TODD MANOR SUBDIVISION, SECOND SECTOR

APPLICATION NUMBER 15 DATE July 5, 2007

DETAIL SITE PLAN

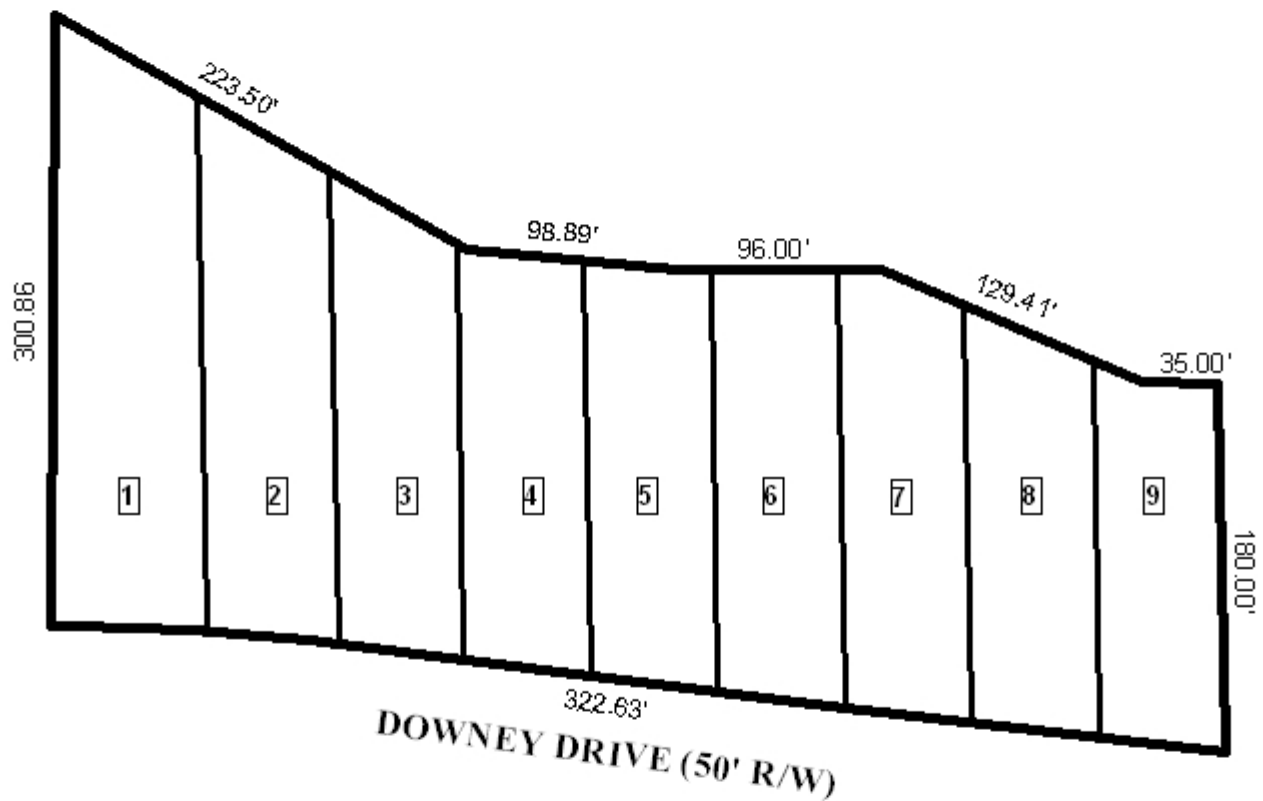
The site exceeds the maximum width to depth ratio as recommended by Section V.D.3. of the Subdivision Regulations. Lots 1 – 8 are indicated as being 60' wide, and Lot 9 is indicated as being 61' wide. However, narrow, deep lots are typical in this neighborhood; thus a waiver of V.D.3. would be appropriate.

The site fronts on Downey Drive; therefore a note should be placed on the final plat stating that each lot is limited to one curb cut with the size, location, and design to be approved by Traffic Engineering.

No building setback line was indicated on the plat; therefore, the 25' minimum building setback line along Downey Drive should be indicated on the final plat.

- 5) revision of the plat to label each lot with its size in square feet, or provision of a table on the plat depicting the same information.

With a waiver of Section V.D.3. (width to depth ratio), the plat will meet the minimum requirements of the Subdivision Regulations and is recommended for Tentative Approval subject to the following conditions:

- 1) each lot is limited to one curb cut with the size, location, and design to be approved by Traffic Engineering;
- 2) placement of a note on the final plat stating that the approval of all applicable federal, state and local agencies is required prior to the issuance of any permits or land disturbance activities;

- 3) depiction of the 25' minimum building setback line along Downey Drive;
- 4) subject to the Engineering Comments (All storm water must be conveyed to a City of Mobile storm water system. The engineer must perform an analysis to determine if the existing system is adequate to convey the additional flow from the development. Show the flood plain on the plat. Show the minimum finished floor elevation on each lot touched by the flood plain. It is the responsibility of the applicant to look up the site in the City of Mobile (COM) GIS system and verify if NWI wetlands are depicted on the site. If the COM GIS shows wetlands on the site, it is the responsibility of the applicant to confirm or deny the existence of wetlands on-site. If wetlands are present, they should be depicted on plans and/or plat, and no work/disturbance can be performed without a permit from the Corps of Engineers. Must comply with all storm water and flood control ordinances. Any work performed in the right of way will require a right of way permit.); and
